With reference to ~~their~~ ^{his} application, dated 26-1-1926.Mr. Fakir Valjee is informed
~~Messrs.~~ ~~are~~that the plan submitted by ~~them~~ ^{him} for building Shops & house on plot No. 2e Survey Sheet A-27situate in Mahmadsheh Street, Napier
Road

With reference to ^{his}~~their~~ application dated 30.9.24 with aplan for the proposal ^{Building}~~additional~~ on plot No. 2C Survey Sheet No. A.27

PLAN
OF PROPOSED BUILDING ON PLOT
N^o 23 SHEET N^o A-27 NAPIER QR:
SCALE 8'-1"

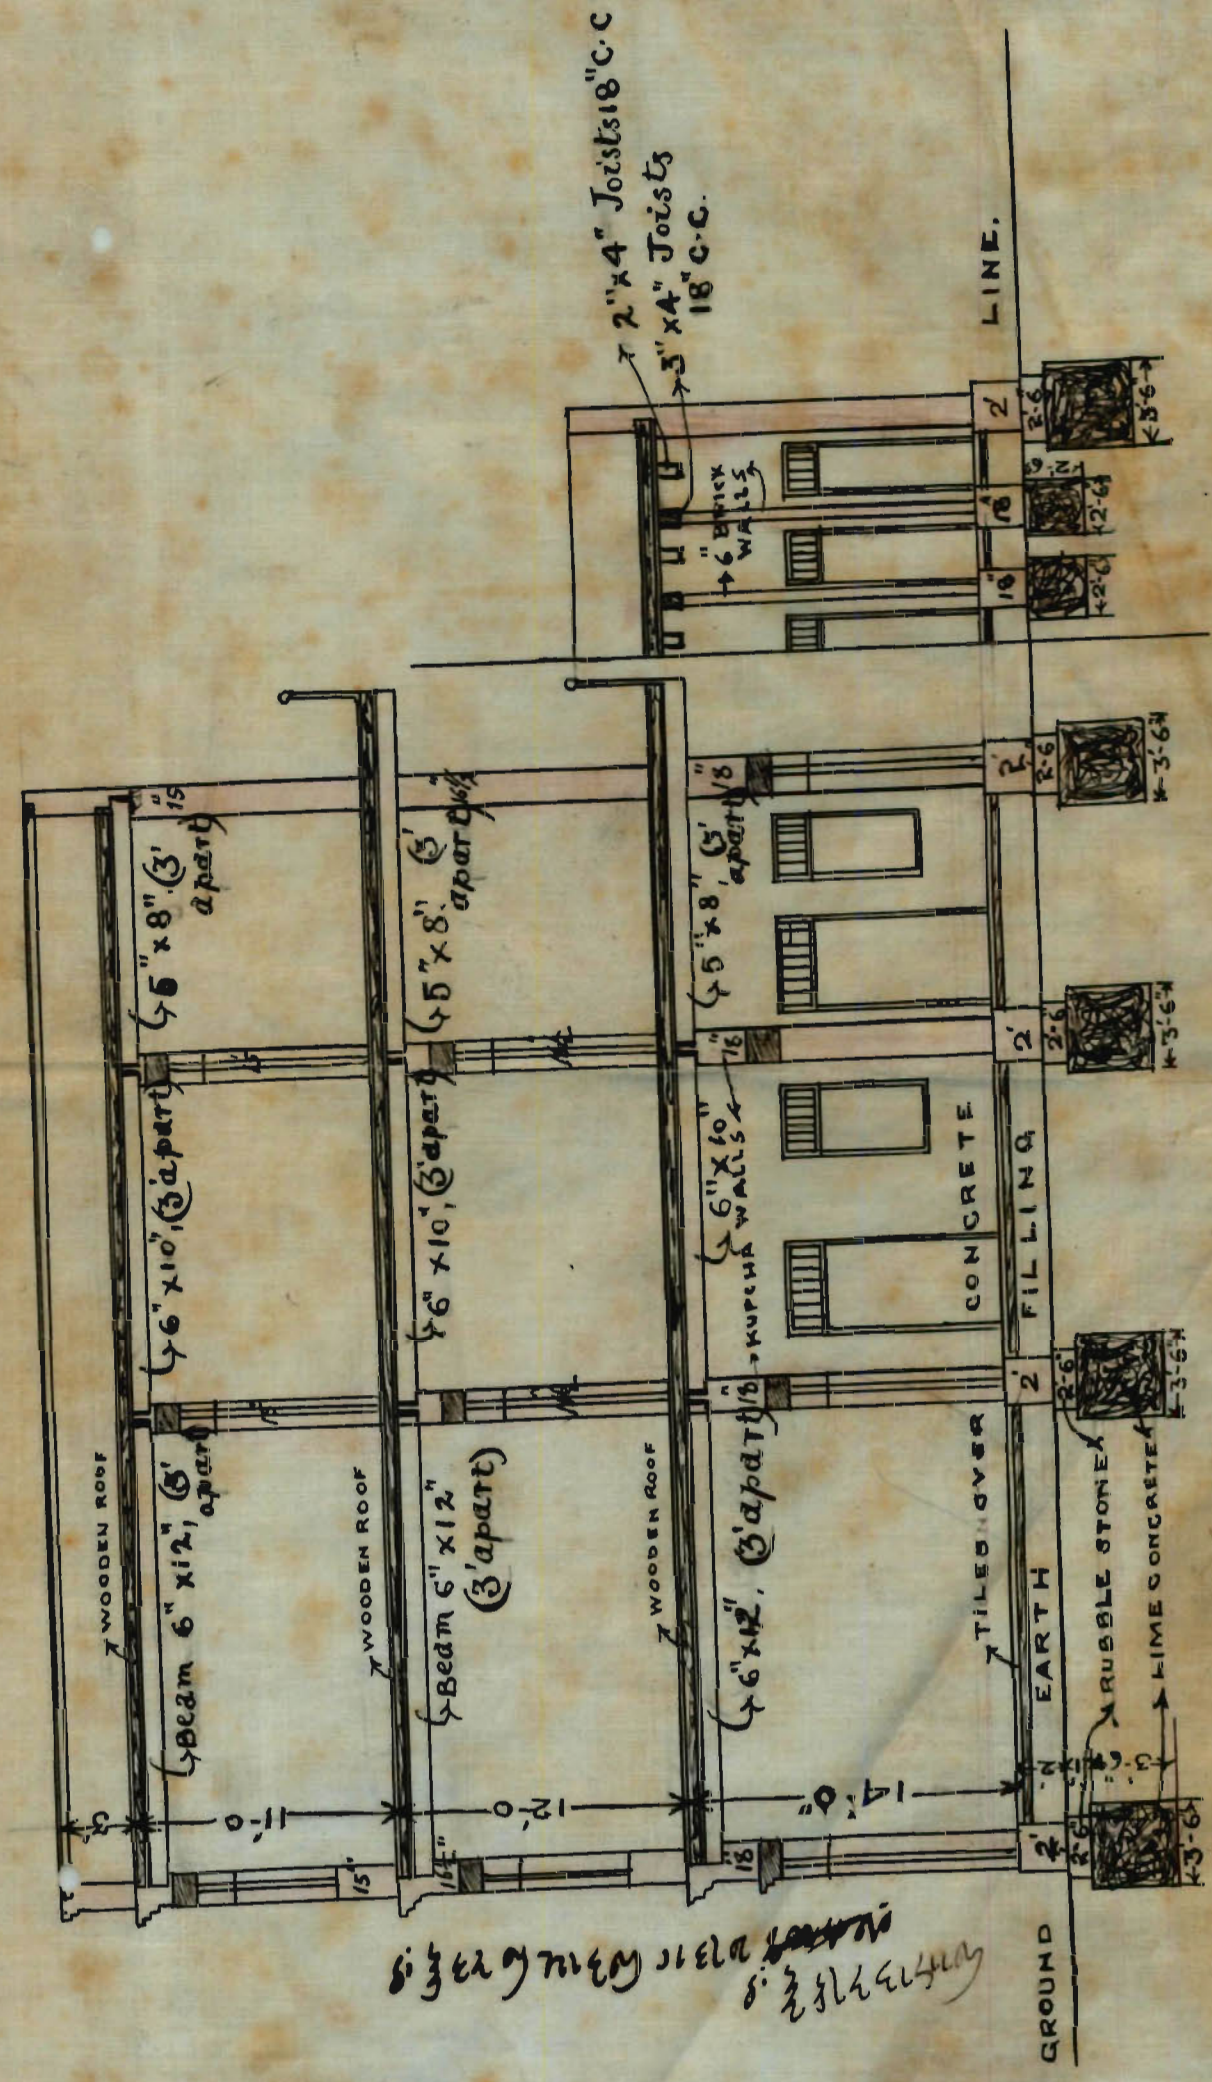
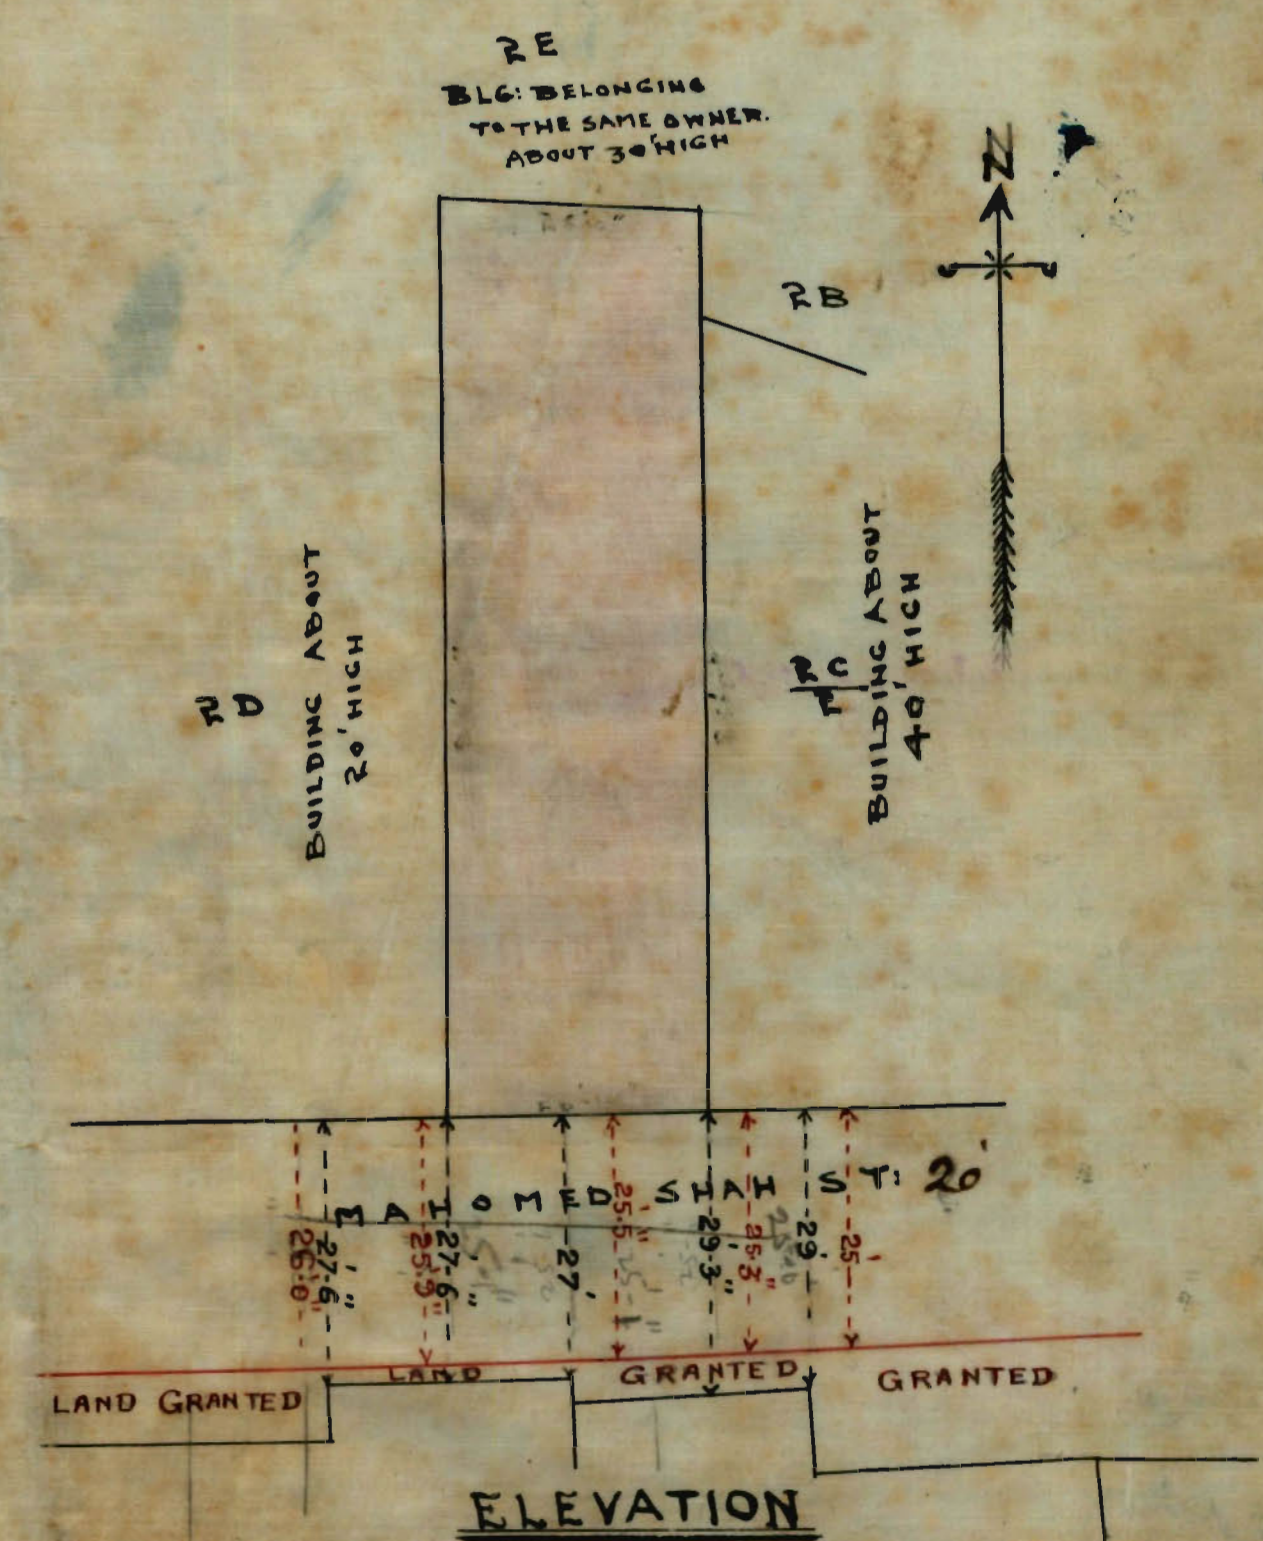
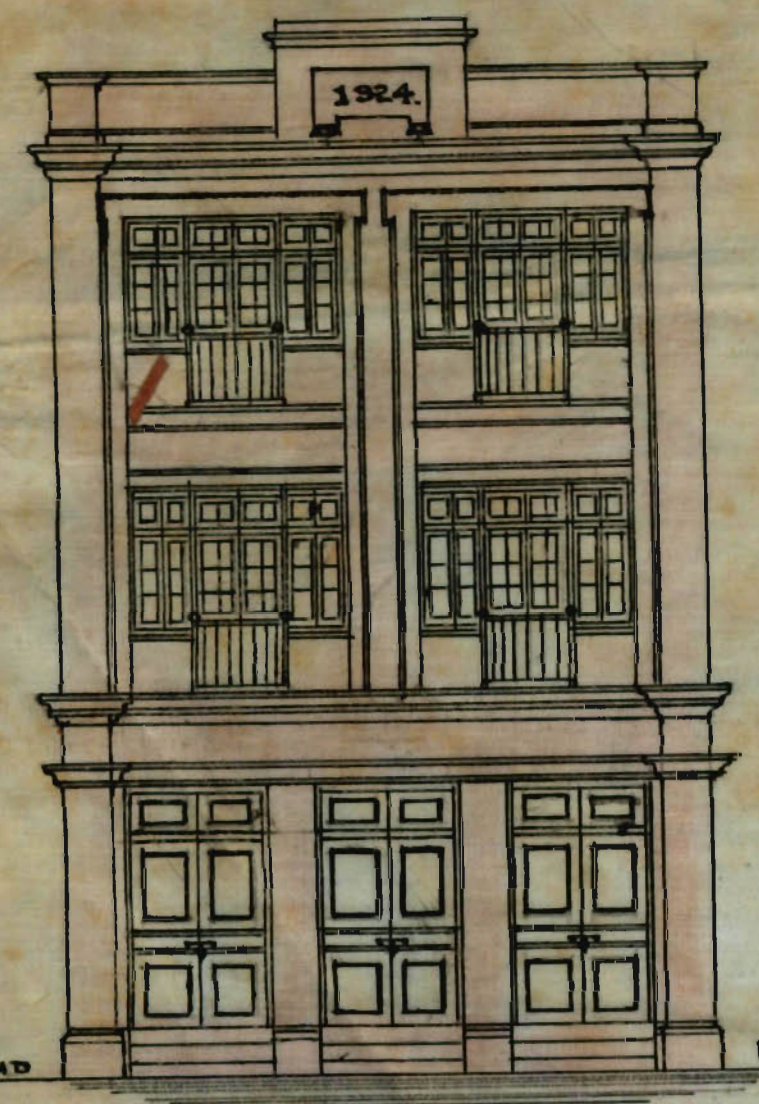
- (1) Central rooms are dark & ill-ventilated.
- (2) Porch must be provided in partition wall.

- (3) Return of P. wall should be specified.

- (4) The site measurements do not tally with the City Survey record. He must produce certified copy of the City plan & correct the plan accordingly.

- (6) Beam for 18 feet span carrying P. wall must be 15x8. Beam to carry P. wall for 13 ft. should be 13x7, for 10 ft. should be 12x6.

Please show the opposite side of the road & actual line of the building. Show whether there is a wall or not.

Central rooms are dark

1. ports must be provided in p. water
2. retainer of p. water should be provided
3. open shade room must be done
4. Size of house is 18' ft square must be 12 x 8 1/2

The site measurements do not
tally with the City Survey records.

Beam for 18' carries P. wall must be 15' x 8"

Joist for 18' span 3' apart should be 12' x 6" as above

Beam heavy P. wall for 13' span should be 13' x 7"

an the objections have now been carried out and an architect has brought in certified copy - Report order to pass the plans. See plan in file.

Plans passed.
